HISTORIC AND DESIGN REVIEW COMMISSION

October 04, 2017

HDRC CASE NO: 2017-510
ADDRESS: 401 E HOUSTON ST
LEGAL DESCRIPTION: NCB 417 BLK 19 CIR 6 & W 1.1 FT OF 5 ARB A1
ZONING: D, HS
CITY COUNCIL DIST.: 1
LANDMARK: Burns Building, Washer Bros Building
APPLICANT: Ann McGlone
OWNER: Area Real Estate, LLC
TYPE OF WORK: Door replacement, entry modifications
REQUEST:

1. Modify the street level entrance on Jefferson Street and install a perforated metal access gate.

LOBBY - ENTRY

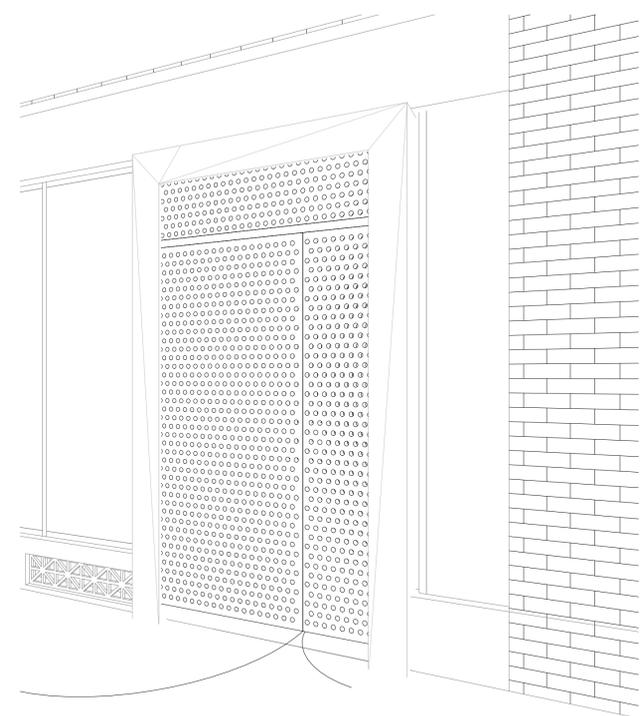
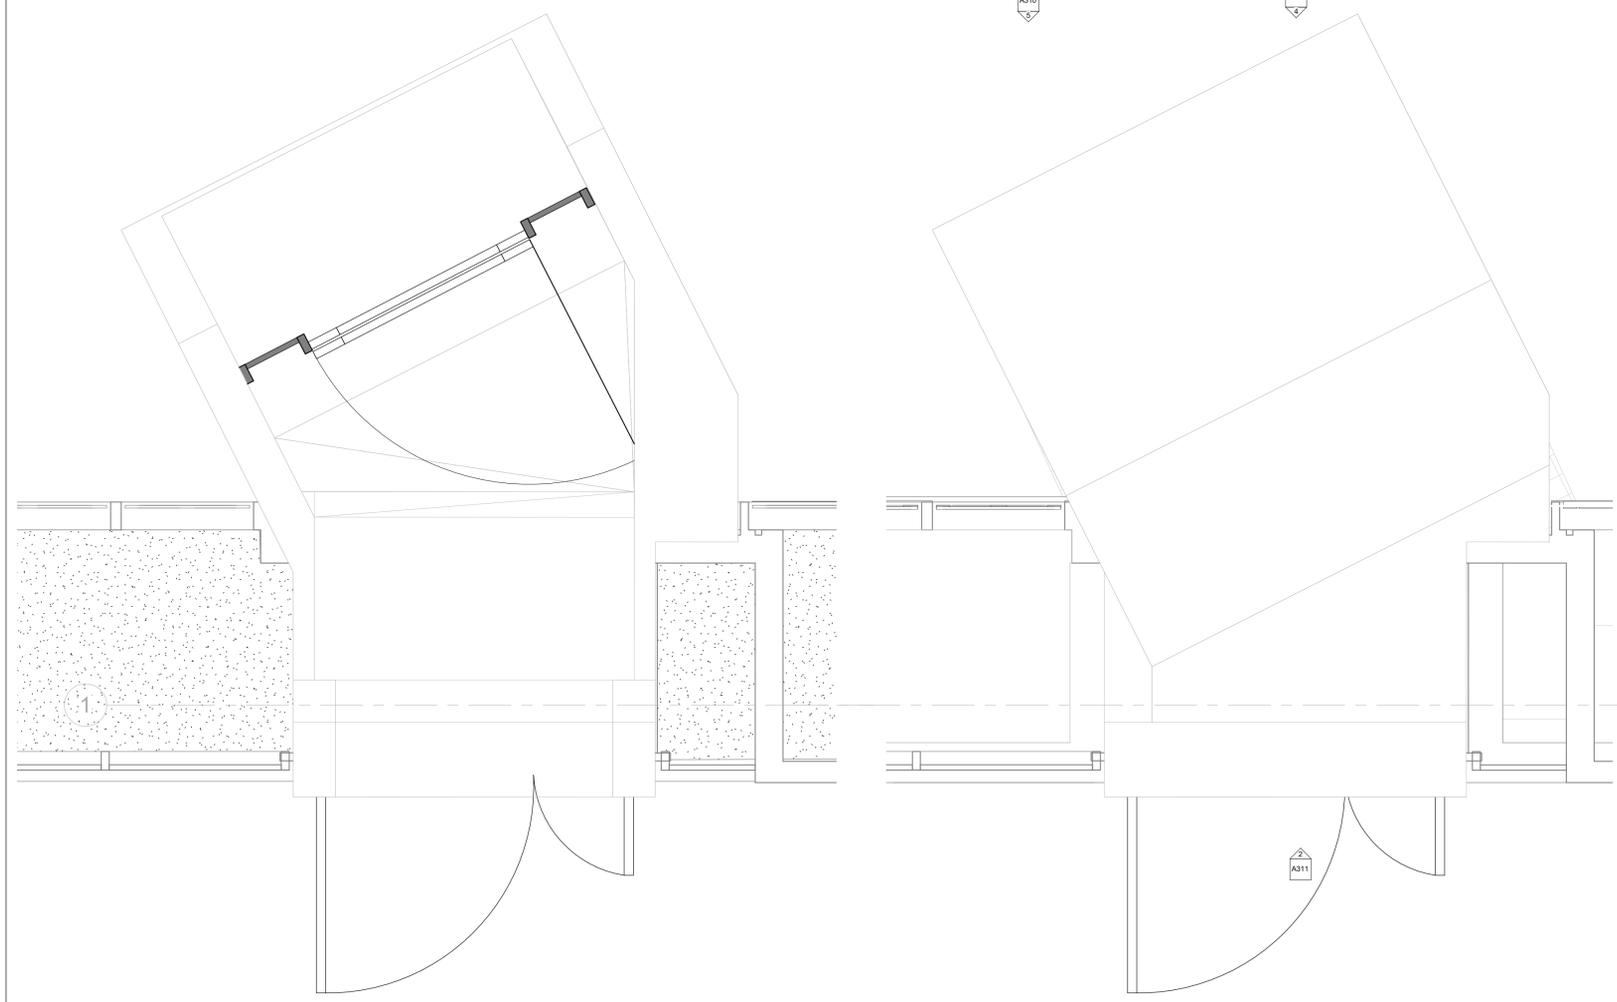
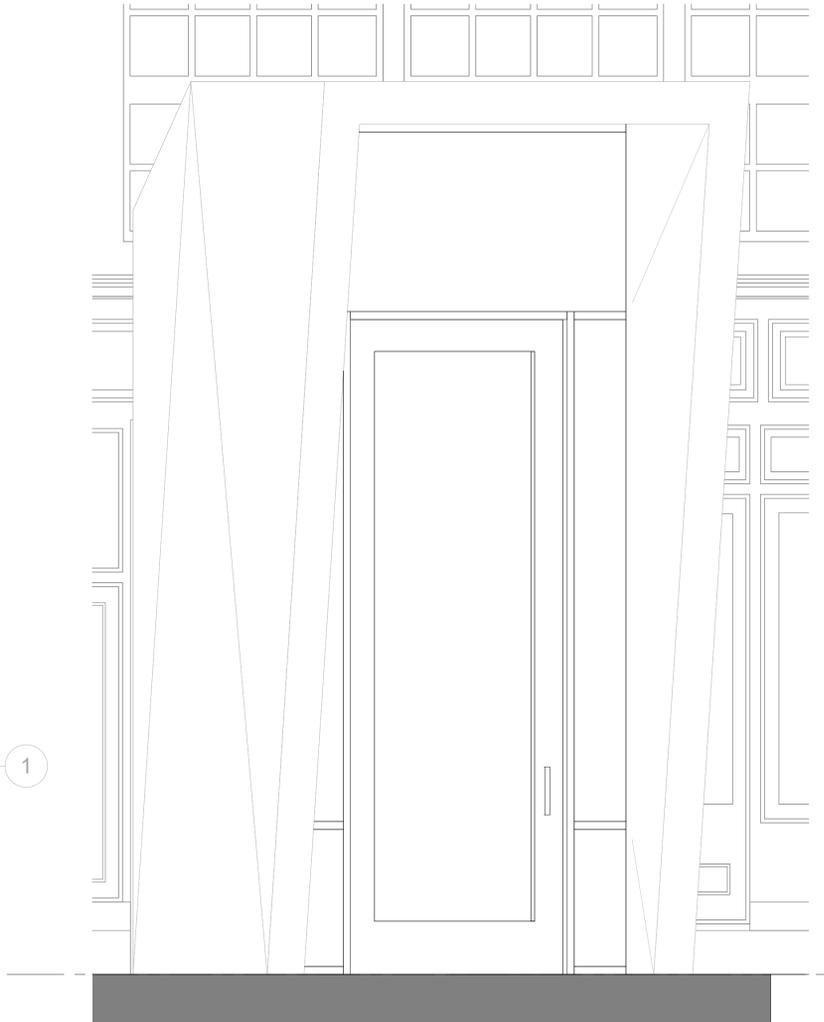
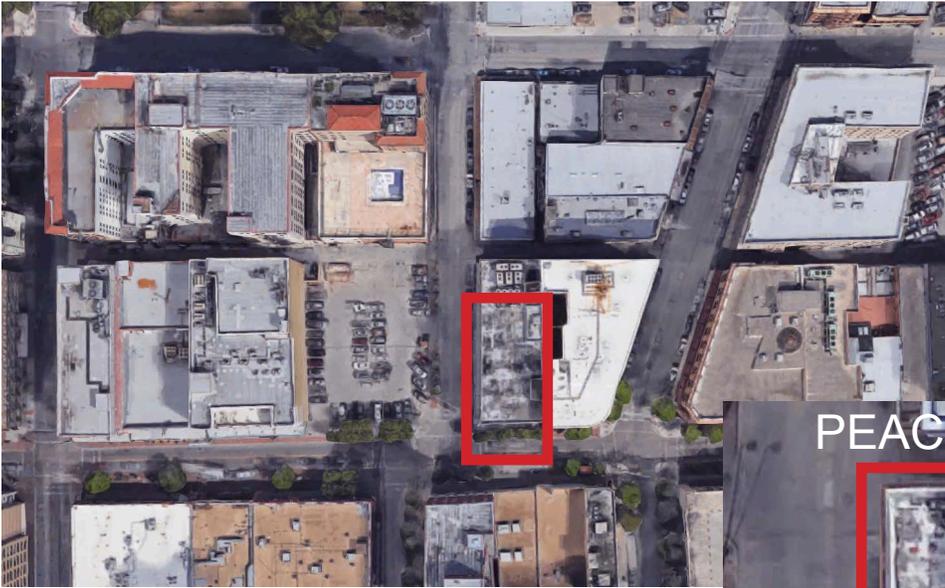
- b. The applicant has proposed to modify the street level entrance on Jefferson Street by installing a perforated metal access gate. The proposed gate will be installed in a manner that will remove the existing vestibule from view. Within the vestibule, the existing, non-original door will be replaced and the opening will be modified by increasing the depth of the vestibule and installing an off-axis opening. The proposed new door entrance will be located to the rear of the storefront system.

commercial to residential. Alterations should not disrupt the rhythm of the commercial block. Staff finds that the proposed modifications are reversible, will be performed in a manner that will not remove historic elements and will not negatively impact the architectural character of the historic structure.

Staff recommends approval as submitted based on findings a through d.
